# CHABOT – LAS POSITAS COMMUNITY COLLEGE DISTRICT

January 10, 2008

## **Addendum No. 1** **INVITATION FOR BID NO.: 08-16** **M&O Facility Modular Office Building Manufacturing &** **Installation, Las Positas College**

**A3.01**

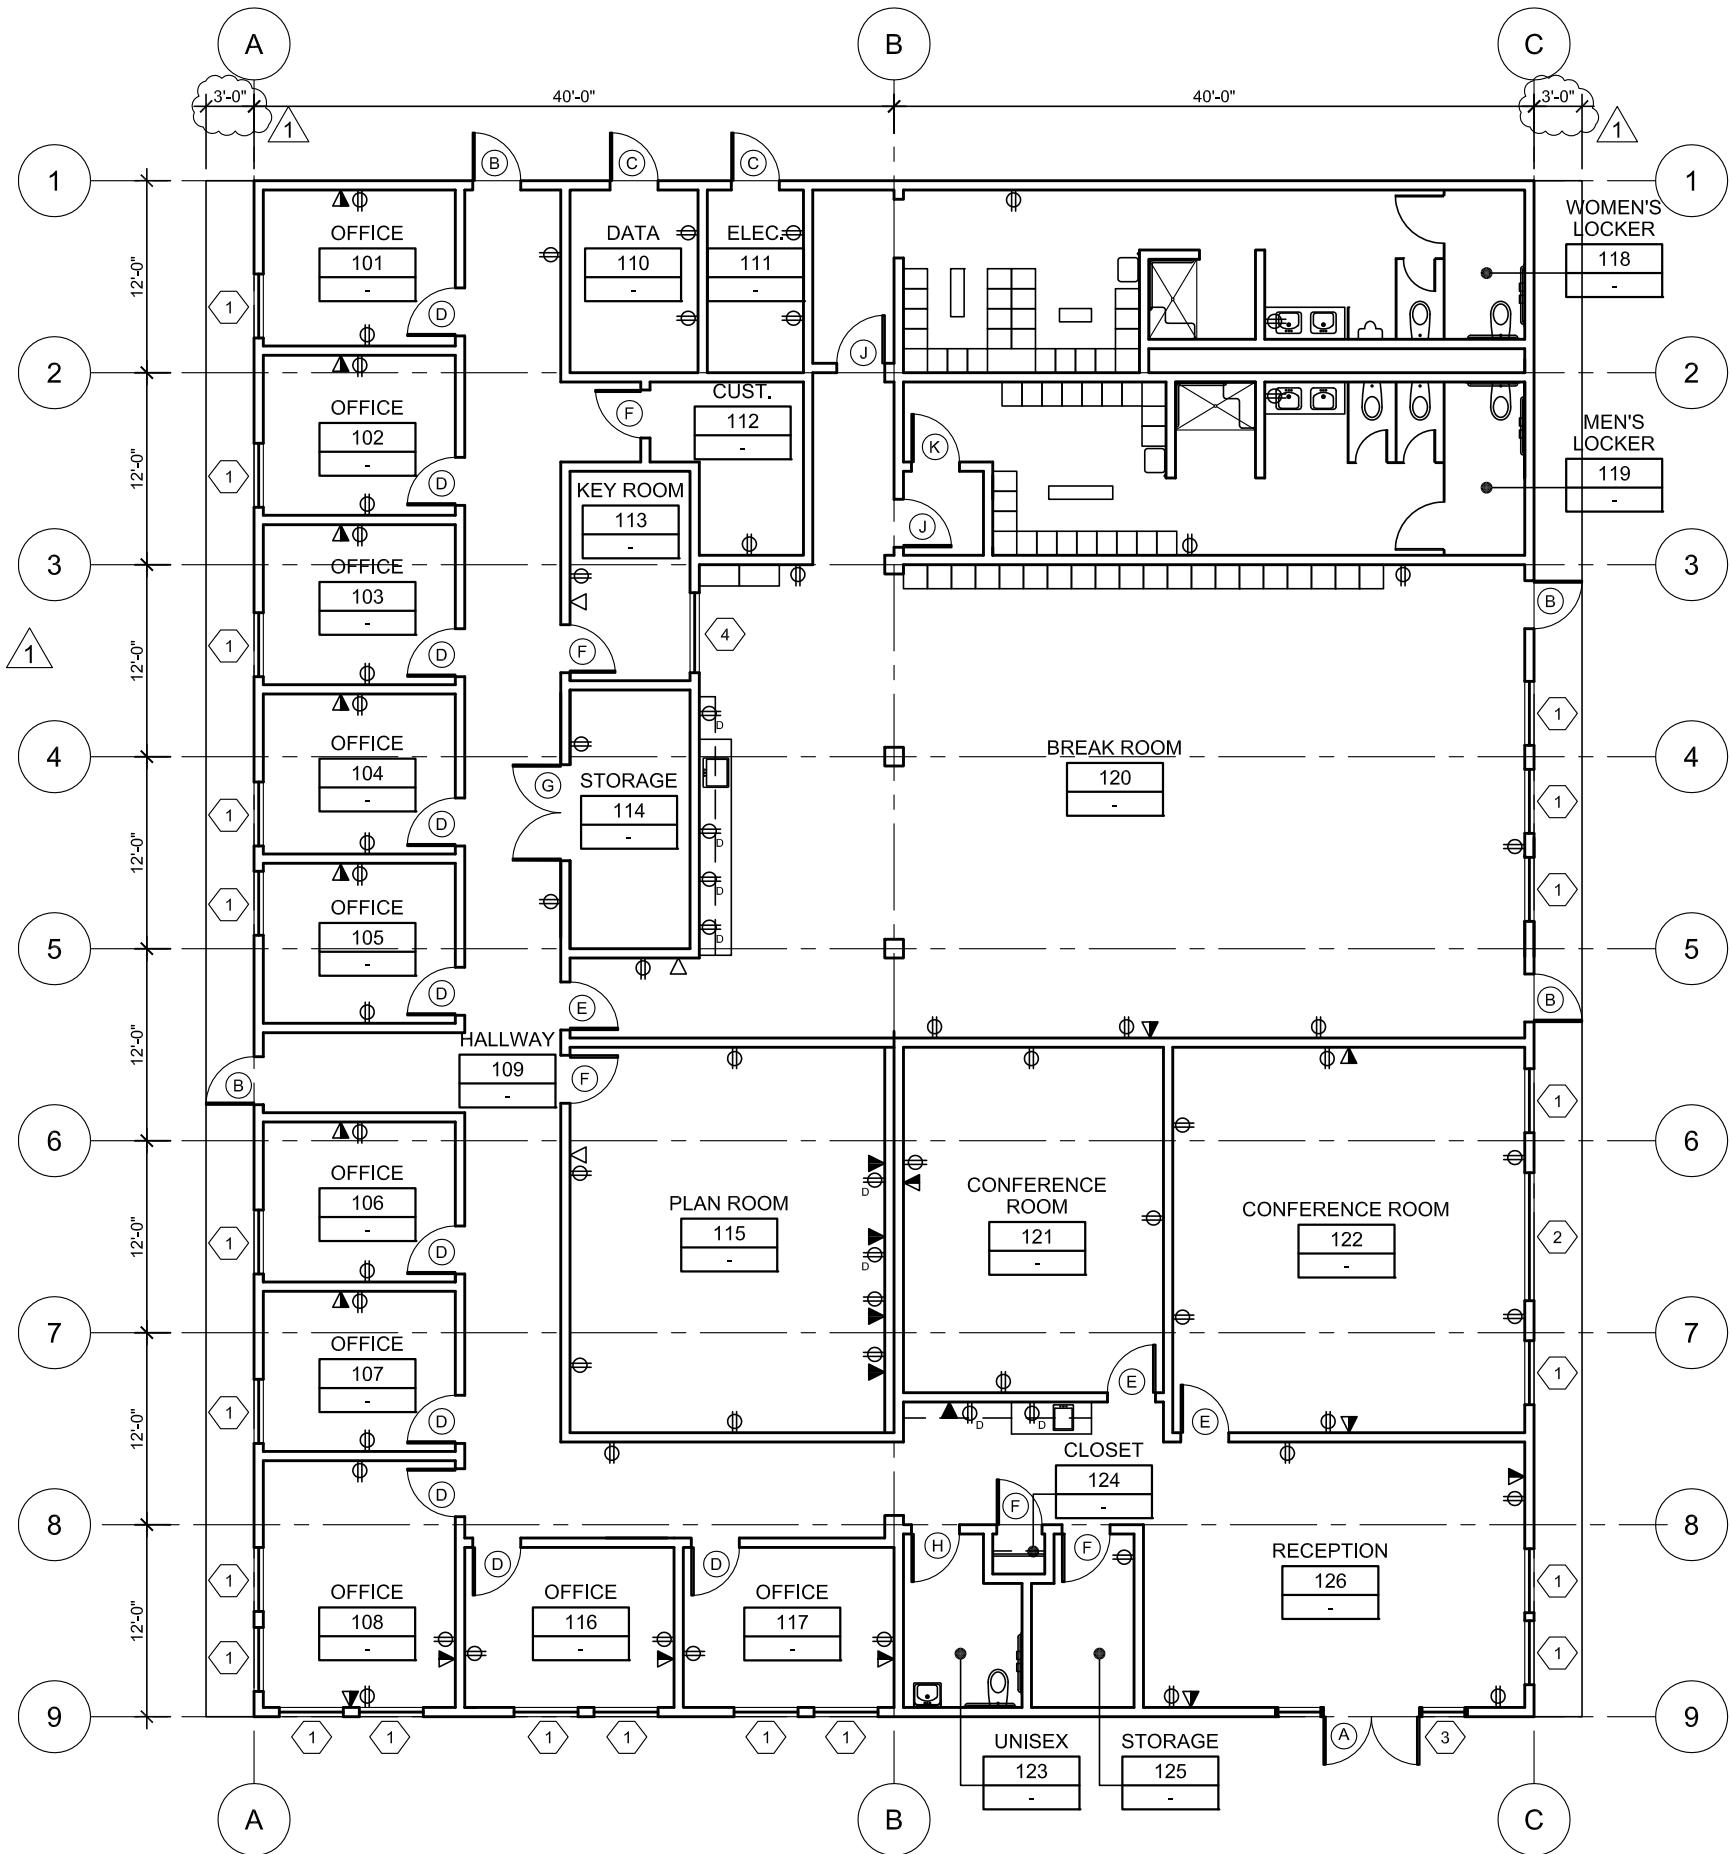
#### Item 4 Sheet A3.01 Office – Floor Plan (re-issued)

- A. Specifications:
  - 1. Modify paragraph 3 to indicate a minimum roof slope of 1/4:12.
  - 2. Add subparagraph 4.a regarding a bid alternate for MDO siding on the building exterior.

- 3. Modify subparagraph 5.b to indicate an 18” high clear crawlspace where plumbing fixtures are located.
  - 4. Add subparagraph 5.d regarding the preparation of a level building pad by the District’s sitework contractor prior to the modular manufacturer commencing the installation of the building foundations.

- 5. Modify subparagraph 8.c to indicate that the lockers in the men’s and women’s restroom are to be metal with factory applied enamel finish.
  - 6. Modify paragraph 9 to indicate that mechanical units are to be gas-fired.

- 7. Add subparagraph 12.a to indicate requirement for occupancy sensors.
  - 8. Add paragraph 19 regarding the pre-drilling of the steel roof framing for fire sprinklers to be installed by District’s site contractor.

- B. Floor Plan
  - 1. Add roof overhangs with dimensions.

Response:  
Roof overhangs and dimensions have been added to the revised floor plan sheet A3.01 attached to this addendum.

Response:  
Paragraph 9 of the specifications on sheet A3.01 has been modified to specify gas-fired mechanical units.

**BREAK ROOM 120 CASEWORK ELEVATION**

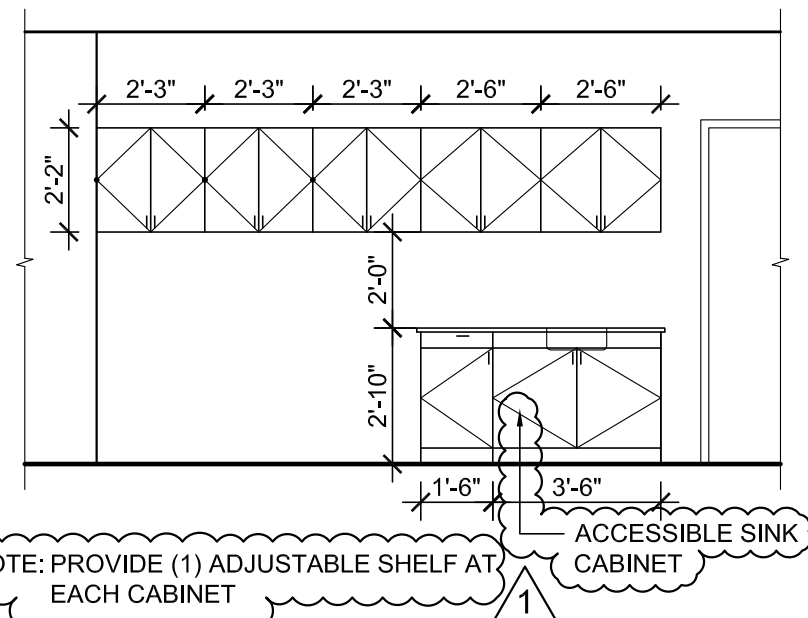
#### Item 5 Sheet A8.01 Casework Elevations (re-issued)

- A. Add note to Breakroom 120 and Reception 126 casework elevations indicating that sink cabinets are to be wheelchair accessible.
- B. Add note to Breakroom 120 and Reception 126 casework elevations indicating a requirement for adjustable shelving at the cabinets.

**A10.01**

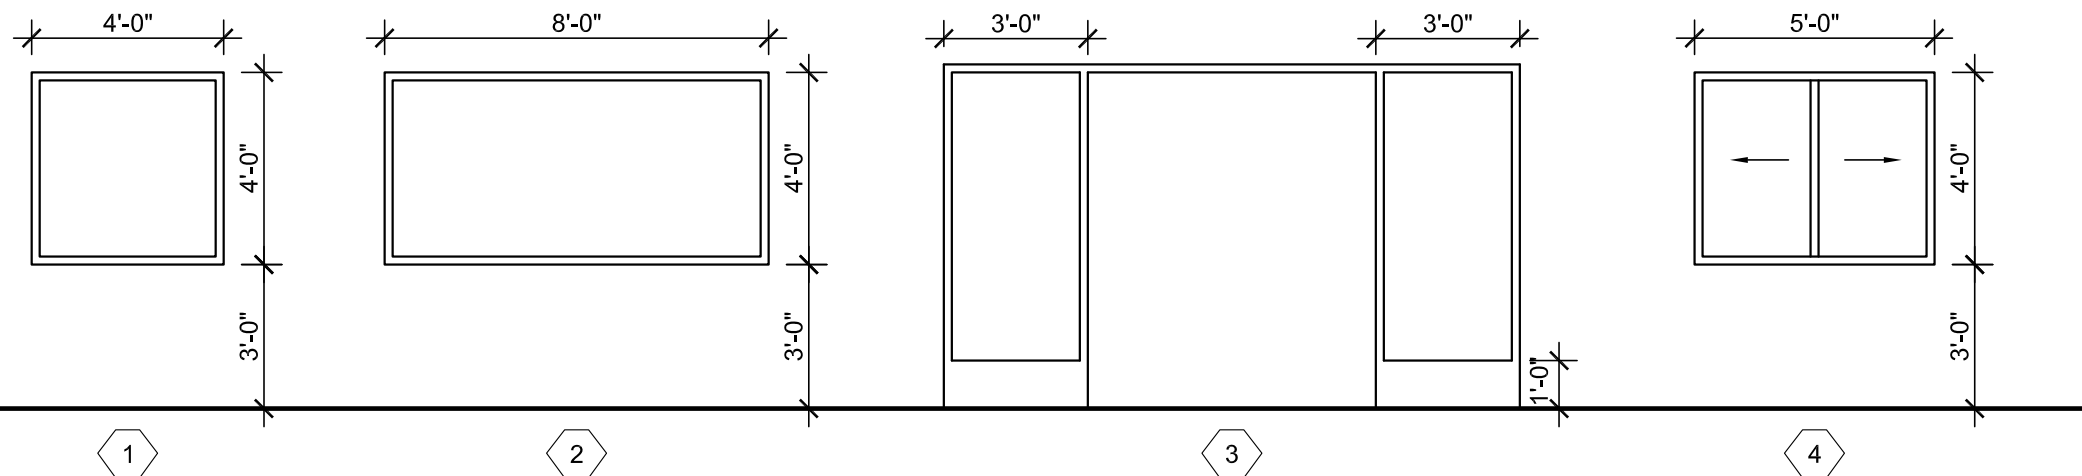
#### Item 6 Sheet A10.01 Window and Door Types, Schedules (re-issued)

- A. Door Schedule
  - 1. Revise identification of door types in door schedule to be consistent with numbering of door types in elevation.
- B. Window Schedule
  - 1. Modify window type 3 to be steel with a painted finish so that it is consistent with the door construction and finish identified in the door schedule.

*On Sheet A10.01 please confirm that the door types should be labeled as "A, B, C" (not 1, 2, 3). See fourth column in Door Schedule.*

*Please clarify what type of Door - Window is specified for Door "A" Main entry at Reception Office: It is shown on the Window Schedule as an Aluminum window (Storefront??) 12' wide to accommodate hollow metal door type "C" (or 3 - see question 4 above). The window elevation on A10.01 for window "3" looks like it should be a Storefront system, but the Door Schedule indicates hollow metal. If the "Sidelight" windows are aluminum and the double door is hollow metal, it will be necessary to include wall framing between windows and doors. The header bar connecting the two sidelight windows is confusing.*

The door types on the door schedule have been revised so that they correspond with the door types "1, 2 and 3". Refer to attached sheet A10.01.

Door -Window type 3 is a steel frame with steel doors flanked by a sidelight on each side. Refer to the revised window schedule on sheet A10.01 attached to this addendum.
